Date: 8/5/2004

T10: T10 Technical Committee (SCSI)

From: Charles Binford, Sun Microsystems, Inc., (charles.binford@sun.com)

Subject: Target Multiport Model

Figure X

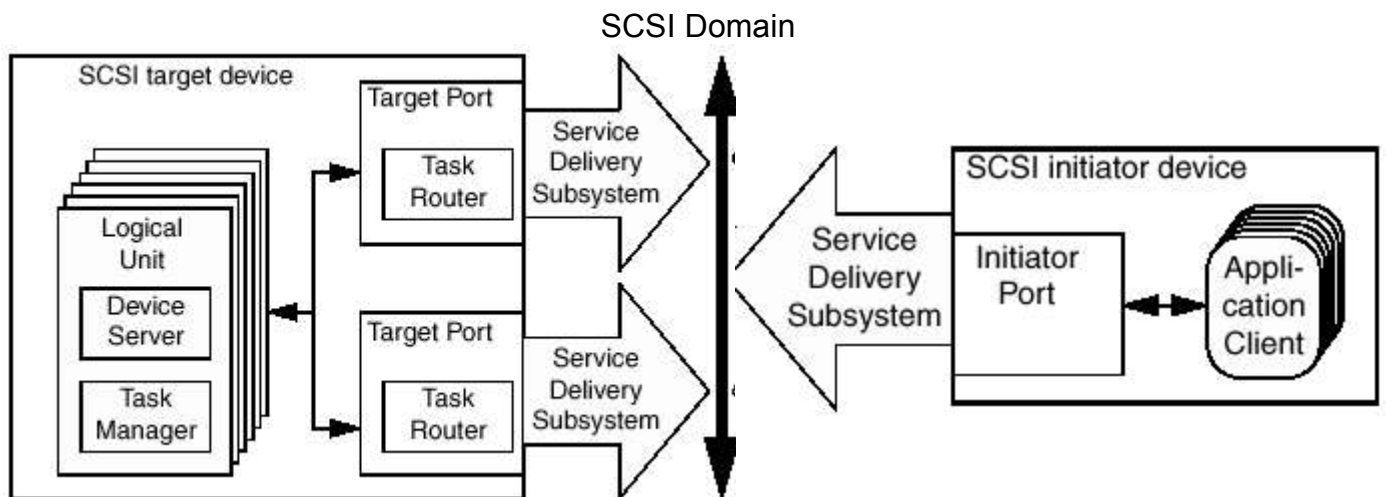
The key question this figure will answer is how many "initiators" does the target see? Should the target differentiate this from figure 21 above?

This subject came up at January's CAP meeting and it quickly became clear that there were different opinions/interpretations of how this configuration is viewed per SAM. Some felt that given the current transports defined for SCSI, that the target can and should figure out that the SCSI Initiator Port Name is the same at treat IOs delivered via either target port as if they were from the same SCSI initiator port.

Others (at least me! :-)) feel that should SAM require the target to treat this configuration as if there were two separate initiators.

With old parallel SCSI there was no question. No mechanism existed that would allow a target device to "figure it out", so it was required to **assume** multiple initiators. While some may argue that parallel SCSI is not applicable here, I say we would be wise to not change the model from what it has been in the past without good reason.

With FCP, for example, it is possible for a device server to figure out whether or not a SCSI Initiator port visible from target port A is the same as the SCSI Initiator port visible from target port B. But, just because it is possible doesn't mean it is a good idea and should be required.

For a redundant array controller configuration, having a device server view Figure X as two separate initiator ports allows for a much looser coupling of the task sets when TST=001b or
